E1-12

202, 1006 (New), 1007 (New), 1014.3, 1015, 1020.1, 1021 (IFC [B] 1006 (New), 1007 (New), 1014.3, 1015, 1020.1, 1021)

Proposed Change as Submitted

Proponent: Charles S. Bajnai, Chesterfield County, VA, ICC Building Code Action Committee

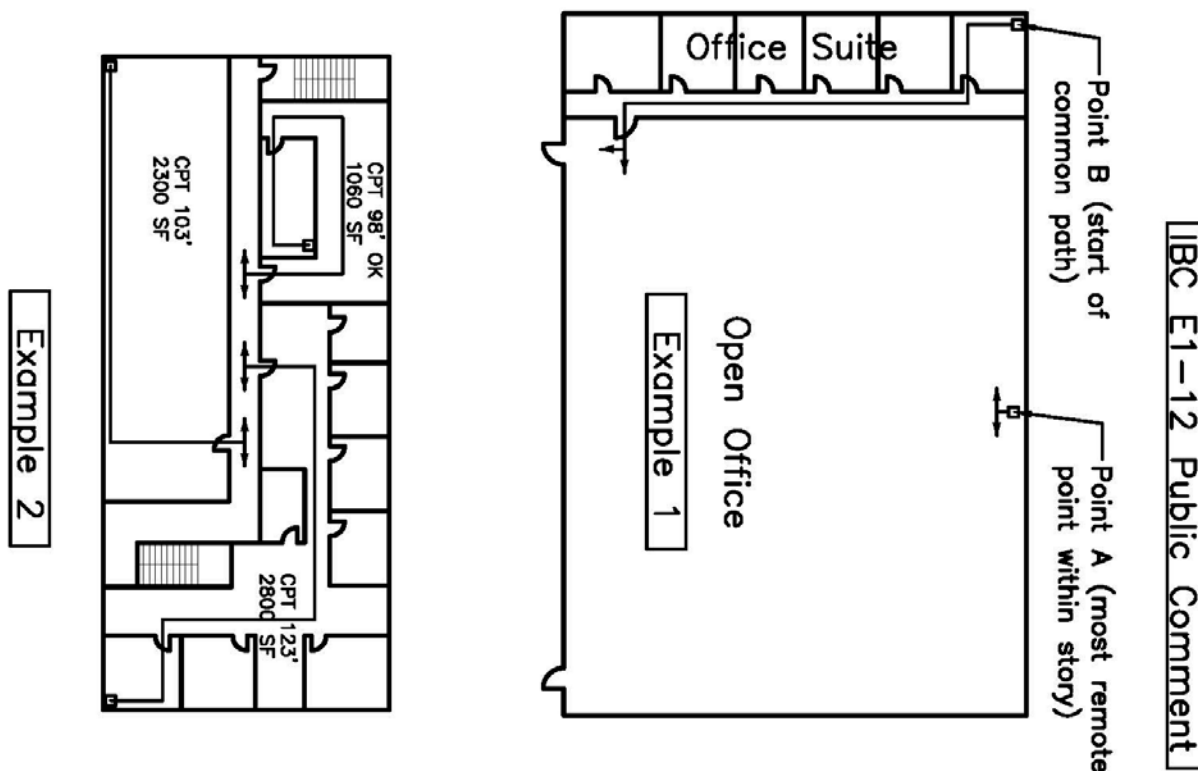
Commenter’s Reason: E1-12 makes improvements to clarify how the maximum occupant load in a space as well as the maximum common path of egress travel both contribute to determining whether or not a space needs two exits or exit access doors.

The new definition approved as part of E1-12 will create more confusion as it refers to a specific instance within a story measured from the most remote point of the story as the only starting point to measure common path of egress travel (see point A in Example 1; E1-12 public comment example). This specific point could coincide with the common path of egress travel starting point but in most instances with different tenants or suites, the starting point to measure common path of travel from a space has nothing to do with the most remote point within a story (see point B in example 1; E1-12 public comment example). There often are multiple points in a story (different spaces) where the common path of egress travel could be critical (see Example 2; E1-12 public comment example).

The intent of the common path of egress travel is to look at the entire exit access not just along the exit access travel distance path from just the most remote point within the story. There is a fatal flaw in the new definition approved along with E1-12. The definition should revert back to the previous definition until a new definition can be proposed in the next code cycle or is successfully updated by public comment in this cycle.

IBC 1004.1, Example D

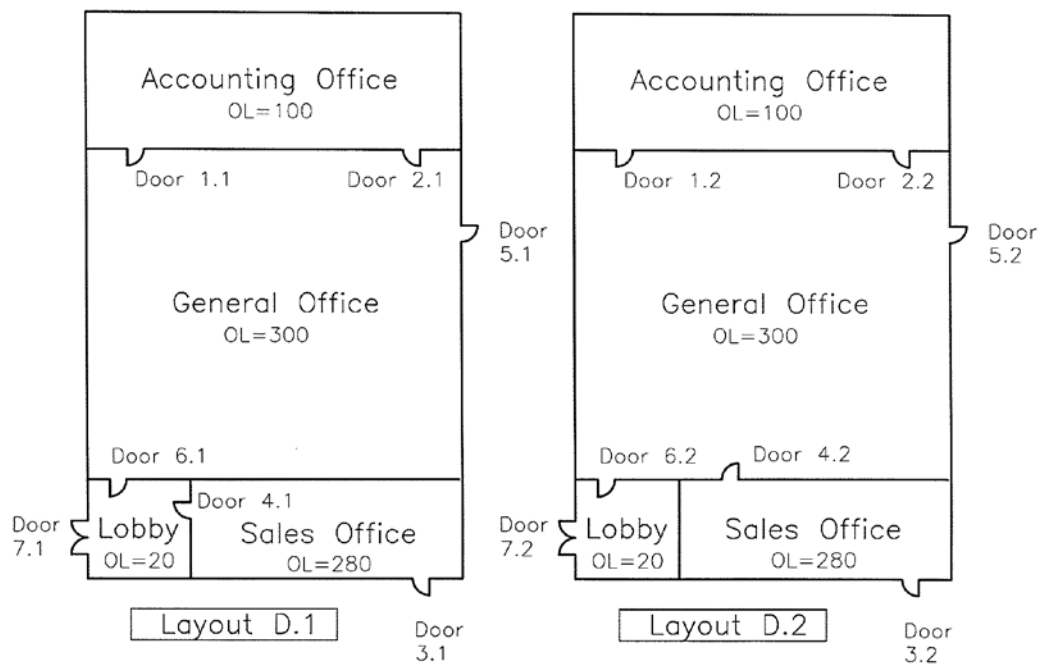
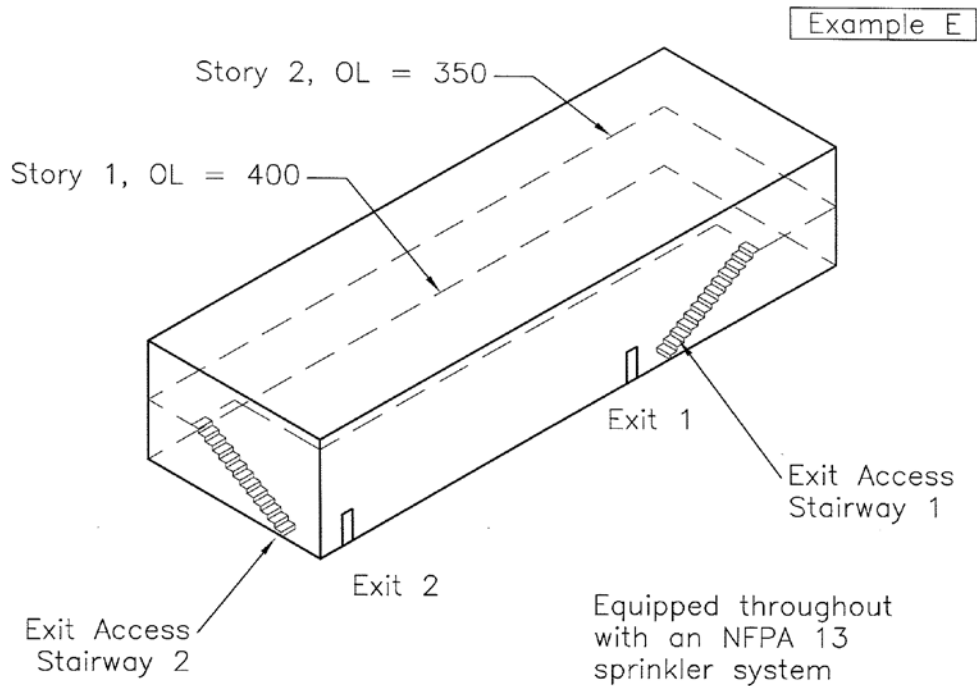
In layout D.2, all rooms have adequate means of egress for the occupant load contained in the room when evaluated on an individual basis. The occupant load of the entire story is still 700 and the story has an adequate number of exits when looked at in the aggregate (doors 3.2, 5.2 and 7.2). Since the sales office also has required egress through the general office, the accounting office, general office and sales office must be looked at in the aggregate and based on the total aggregate occupant load of 680 for this portion of the exit access. Three exit or exit access doors are required and provided from this portion of the exit access (door 3.2, 5.2, and 6.2). The capacity of door 5.2 and 6.2 must be designed based on an accumulated occupant load 270 along each egress path which is determined as follows: (140, the portion from the sales office, plus 100 from the accounting office, and 300 from the general office) all divided by 2= 270. The capacity of door 7.2 is determined based on the occupant load of 270 used to determine the occupant load of door 6.2 along with the accumulated occupant load of 20 from the lobby for a total occupant load of 290 for the capacity of door 7.2 along the continuation of this egress path. This is consistent with Figure 1004.4.4 of the 1012 IBC Commentary and its accompanying explanation.

Egress in layout D.2 would meet the code as revised by the proposed change.

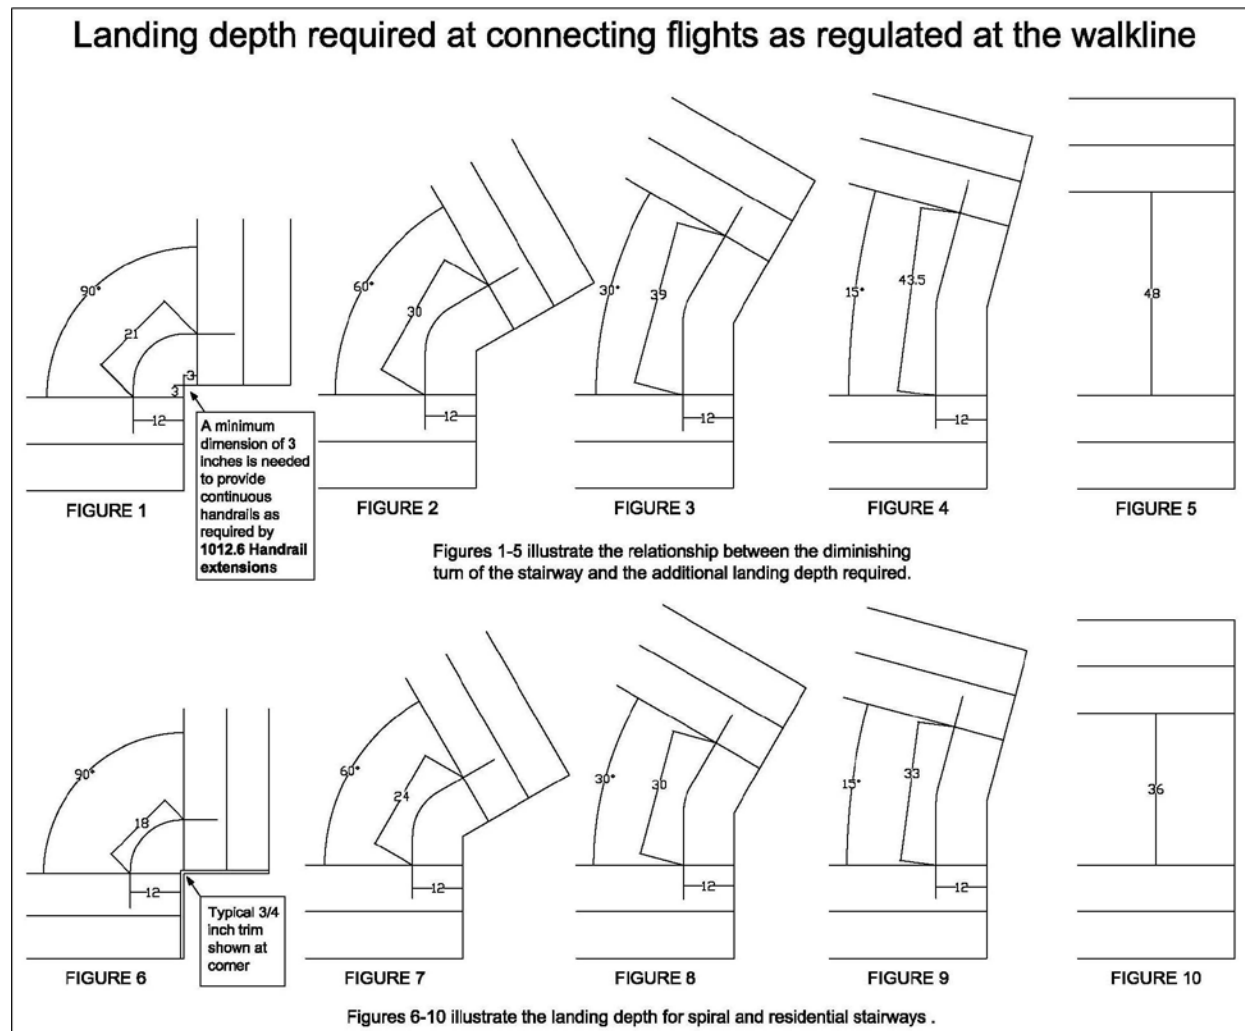
As illustrated in Figures 1 - 10 this proposal requires the landing depth increase as the angle of the turn diminishes to prevent overstepping of the landing and allow the space required to negotiate the turn. This correlates with the 48 inch "need not to exceed" depth of landings specified for stairways with straight runs currently in the code. Figure 1 and 6 shows a minimal 90 degree landing as built in accordance with the code. The landing in figure 1 has the minimum dimension necessary to provide for the continuous handrail connection as required in **1012.6 Handrail extensions**. The minimum landing currently possible has a depth at the walkline as shown of 21 inches and is the minimum allowed by this proposal for a landing turn of 90 degrees. Since the code currently has a "need not exceed limit" of 48 inches applicable to the condition where the stairway is straight run a simple linear relationship between these two conditions allows for calculation of the data in **Table 1** increasing the landing depth by a constant increment as the turning decreases. Figures 2-5 clearly illustrate examples from the table.

Figure 6 shows a typical residential landing and figures 7-10 again illustrate examples from the table and the incremental increase needed for both spiral stairways and residential applications.

It should be noted that this proposal further provides a viable landing depth whether or not the adjoining flights are curved as it is related to the degree of turning only at the landing of the stairway.

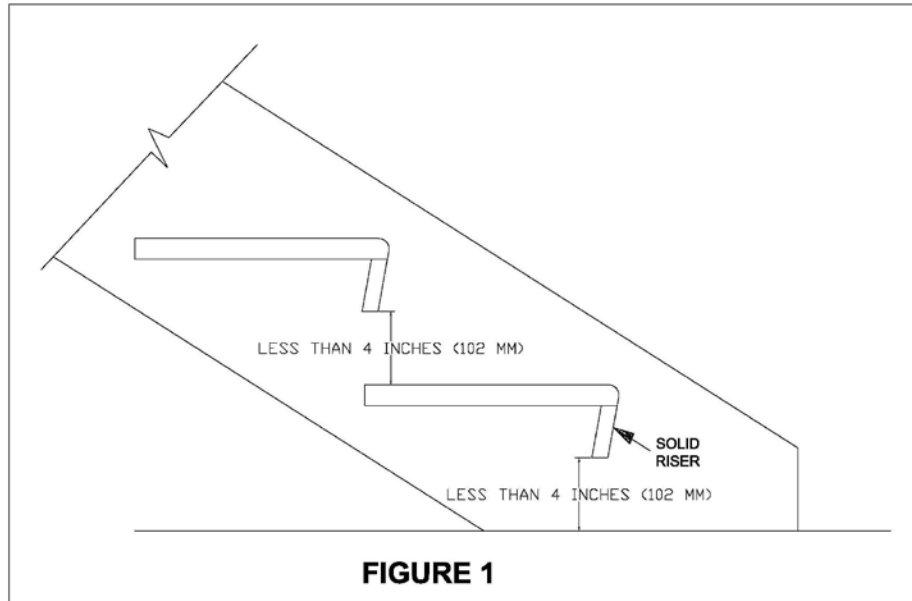
Reason: Section **1009.7.5 Nosing and riser profile** is a constant source of controversy and misunderstanding. The reference to solid risers does not belong in the section that describes the profile or outline of a step. Notably masked in exception 1 by double negatives is the requirement for the limitation of openings in risers.

This proposal clarifies the scoping for use of solid risers and coordinates with the new ADA guidelines as outlined by the CTC. **Solid risers**, as a new and separate section subsection of **1009.7 Treads and risers** will appear prior to Nosing and riser profile. This allows easier identification of the opening limitation between treads and adjoining floors or landings that was previously misunderstood or not found. Exceptions 2 and 3 are similar to the CTC's proposal but assures that an opening limitation applies to Type B units as well as egress stairs and also provides that if an opening is used in the riser, it is in the lower portion of the riser

height, as shown in **Figure 1**, allowing design options that may provide additional heel clearance in descent and the appropriate design of tread nosings compliant with ADA guidelines that are important in ascent.

Figure 1 Residential Range = 7.58" (193mm) – 7.74" (197mm), Commercial Range = 6.84" (174mm) – 7" (178mm) see Table 1 Please note that the described circled ranges have been added to figures 1&2 by the proponent for the purpose of explanation.

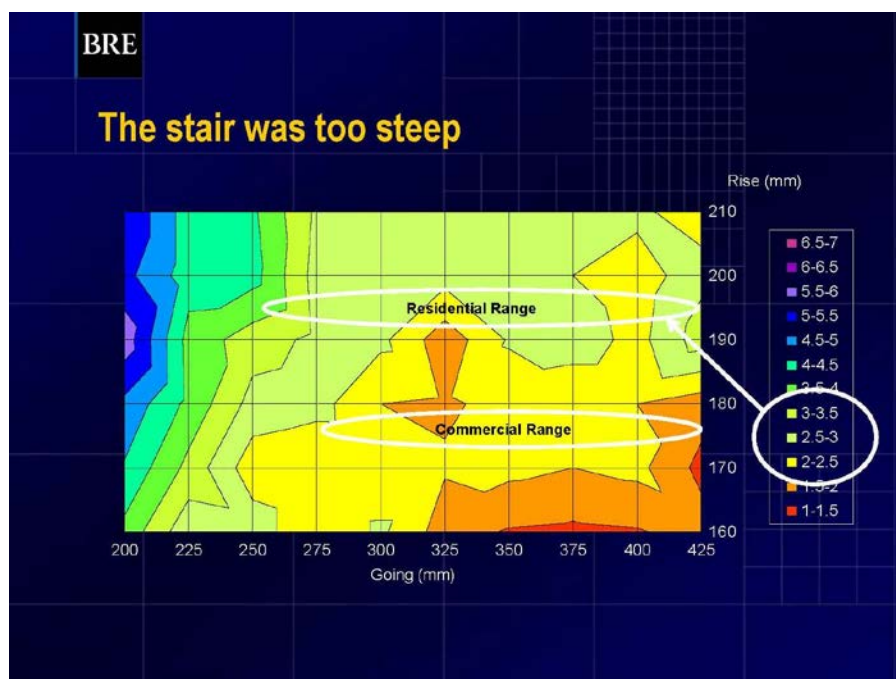
The elevation of 147 inches is a multiple of the maximum riser heights of, 7 inches (178 mm) commercial and 7-3/4 inches (197 mm) residential, allowed for IBC stairways. (See Table 1) This minor change of just 3 inches (76 mm) in the total rise of the flight would in many cases eliminate the cost of incorporating a landing and the space required, in many instances reducing costs of construction. As can be seen in the table below this change would require no additional steps in the stair than the current code requires and a change in riser height of just 5/32 inch (4 mm) or less when the minimum number of risers is desired. This represents no discernable difference consequential to the user.

Testing in support of this proposal, as shown in the data presentations (Figure 1 and 2) from; "The Influence of Rise and Going, Combinations on Stair Safety" by M S Roys, June 2004, 7th World Conference on Injury Prevention and Safety Promotion, Vienna¹, the minor variation in rise does not produce any consequential effect that can be noticed by users when comparing riser heights within the range in question. *Please note that the circled ranges have been added to figure 1 & 2 by the proponent for the purpose of explanation.* Figures one and two can be related to the perceived energy required in ascent as described by the subjective rating of the steepness of the stair and the need to pull oneself up the stair using the handrail. In these figures the user's ratings are on a scale of 1-7 and color coded. The visual display of the data shows little difference in the users ratings over the range in question.

Figure 5

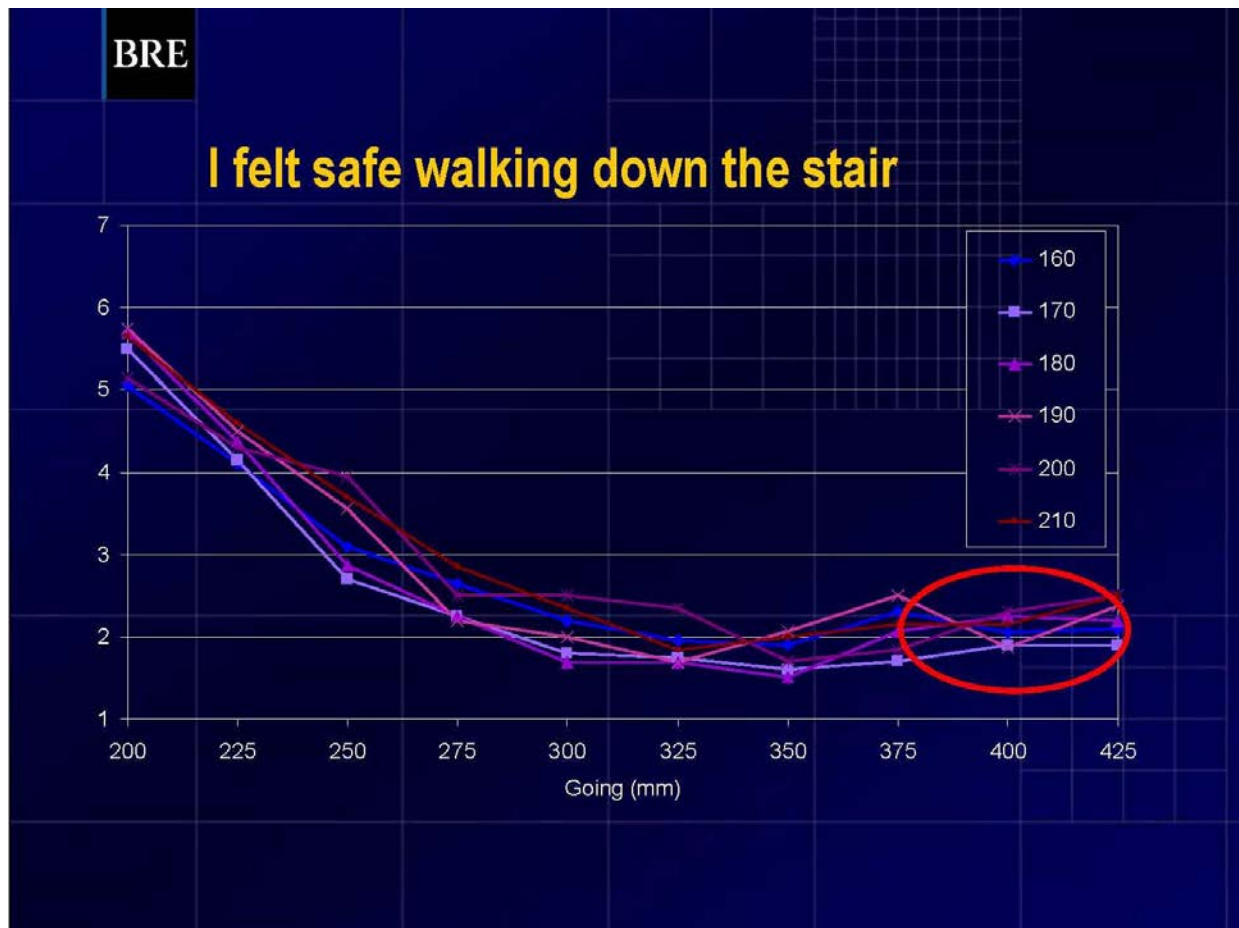
The dimension used for the line of sight indicated by the diagonal lines drawn across the stairs is sixteen inches accommodating the required handrail and the proximal position of the stairway passenger. The position is based on the most common lateral displacement of 350 mm (13.8 inches)¹ from the center of the handrail to the center of the body for the handrail slope of 33° that is common to IBC compliant stairways. Added to this is half the allowed handrail width of 2 1/4 inches and the minimum clearance of 1 1/2 inches totaling 16.4 inches.

The inconsequence of the minor increase in tread depth width is substantiated by testing performed by Mike Roys² as shown in **Figure 5**. Both the 15 inch (381 mm) and 16.7 inch (424 mm) tread depths lie in the same range of preference as indicated within the red circle. *The circle was added by the proponent for the purpose of explanation.*
